**Explanation of Significant Differences
to the Record of Decision for the Interim Remedial Action
of the Northwest Plume at the
Paducah Gaseous Diffusion Plant
Paducah, Kentucky**

Date Issued—September 2010

Prepared for the
U.S. DEPARTMENT OF ENERGY
Office of Environmental Management

Figure 5. Location Two New EWS (EW232 and EW233) in Southern Well Field

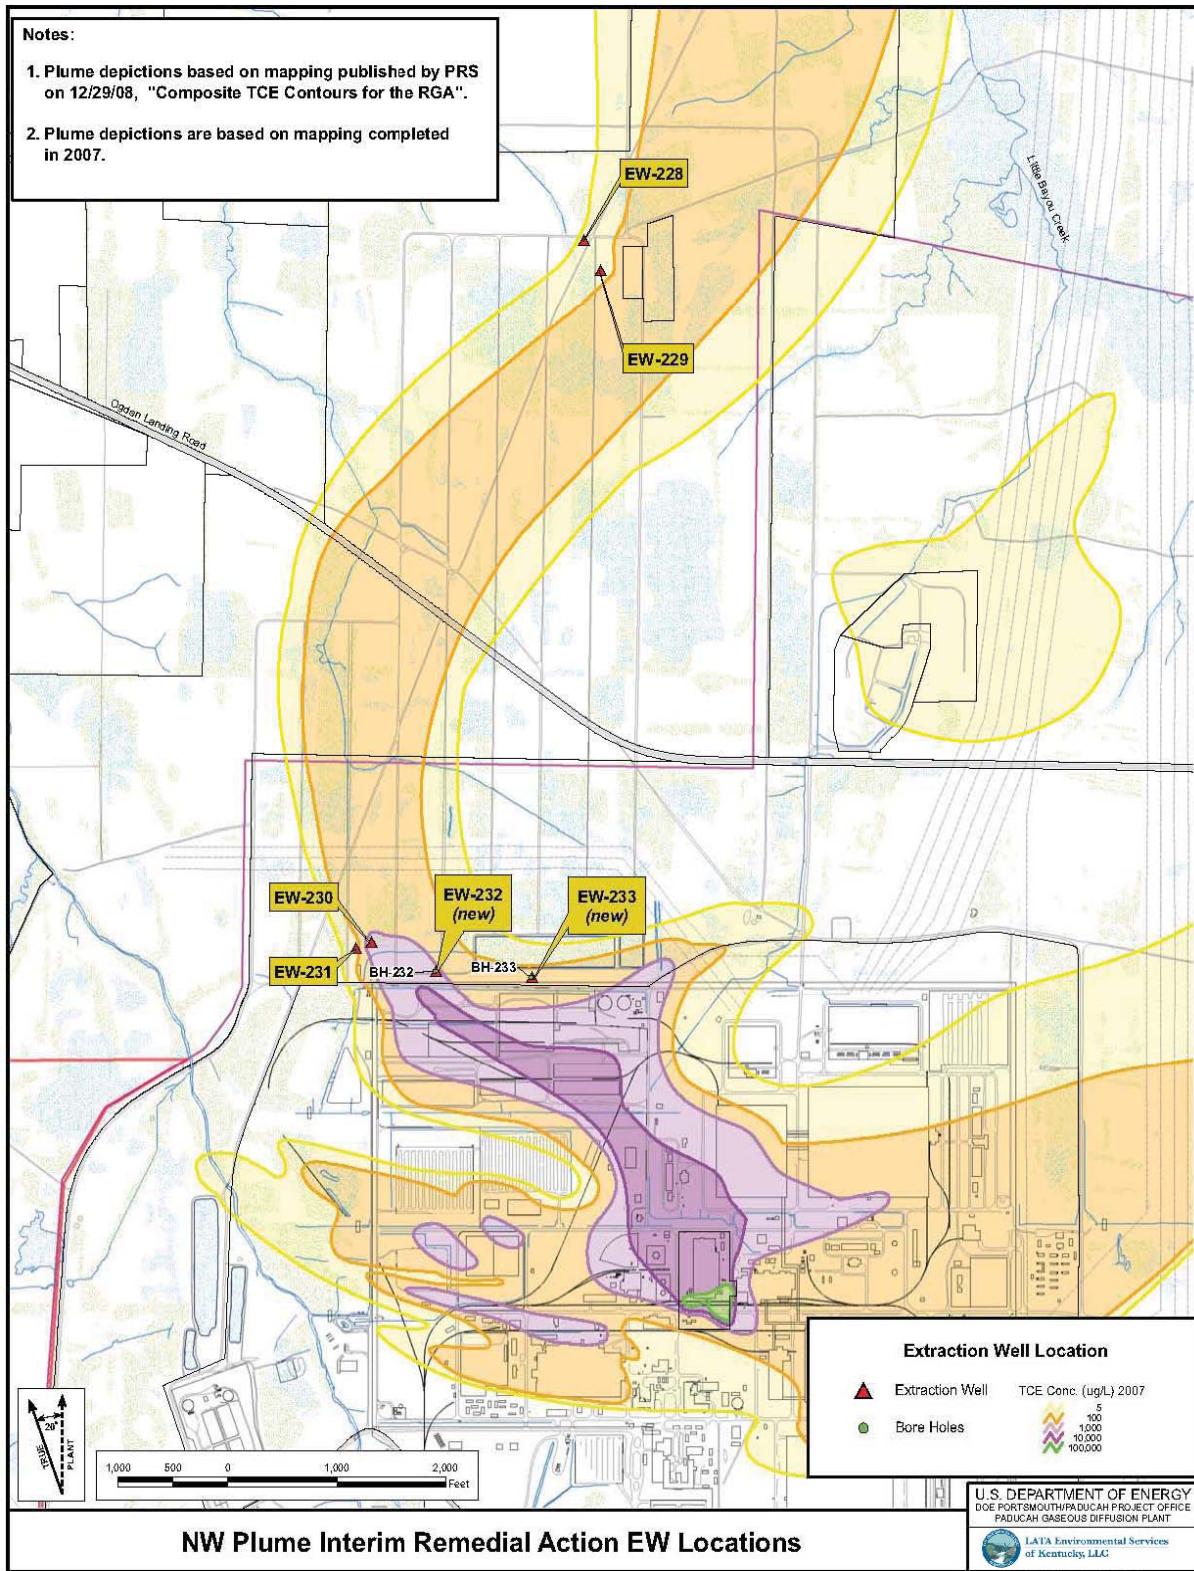
Optimization modeling was performed in late 2009 under the following requirements and assumptions to assess the potential for optimization of the south well field in accordance with the Five-Year Review Report (DOE 2009). The optimization effort was undertaken utilizing the updated PGDP groundwater flow model coupled with the *Brute Force* particle tracking software (Laase *et al.* 1999). Requirements and limitations of the modeling included a maximum theoretical treatment volume of 250 gpm, EWs located near the north fence of PGDP, and contaminant distribution was based on NWP concentrations. Simulations utilizing one, two, three, or four EWs at various locations were performed to determine the best contaminant capture configuration. The simulations identified the two-well configuration to be the most effective on contaminant capture at 99.99% when no anthropogenic recharge is present. The two-well simulations then were run with the actual treatment volume of 220 gpm for the treatment system and identified that contaminant mass capture was 99.87% and 99.97% for anthropogenic recharge and no anthropogenic recharge, respectively. The results of the modeling identified the two-EW system as identified in Figure 5.

- The existing south EWs, EW230 and EW231, are out of service, but will remain in standby mode, to be made operational with minimal effort, and will be replaced by two new EWs located east of the EW230 location.

Well field optimization modeling indicates that a two-well configuration is optimal. The two new wells, EW232 and EW233, are located north of the fence line at the northwest corner of PGDP. Refer to Figure 5 for well locations. The EWs have a design capacity 220 gpm each, as allowable by the formation. Boreholes were installed approximately 10 to 12 ft from the proposed locations for the two new EWs. Detailed lithologic logs and grain size analysis was used in well screen and filter pack design.
